SUBMITTAL IDENTIFICATION SHEET

WEBSTER UNIVERSITY ISB	
PROJECT NAME	
8274 BIG BEND BLVD	
ADDRESS	
NUMBER	
WEBSTER UNIVERSITY	
OWNER	
CANNON DESIGN	
ARCHITECT / ENGINEER	
Ryan Tune	
SUBMITTED BY	
042000-027	
CONTRACTOR / CM SUBMITTAL NO.	CANNON DESIGN SUBMITTAL NO.
	042000
DRAWING / DETAIL REFERENCE	SPECIFICATION SECTION / PARAGRAPH
MANUFACTURER / SUPPLIER	ITEM / PRODUCT ID
REQUIRED DATE	PRIORITY
	☐ CRITICAL

St. Louis Stone

WEBSTER UNIVERSITY
Interdisciplinary Science Building

SITE WALL COPING SECTION

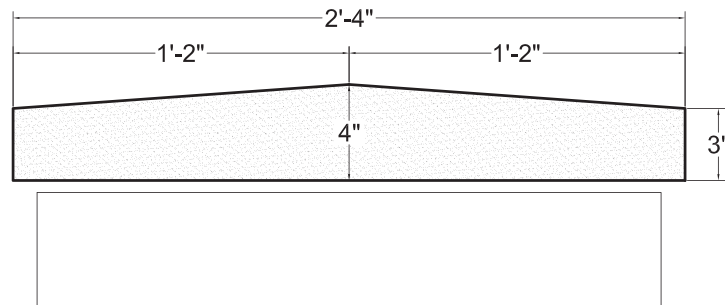
COPING FOR NERINX SITE WALL ACCEPTABLE, PROVIDED IT MATCHES EXISTING COPING DETAIL.
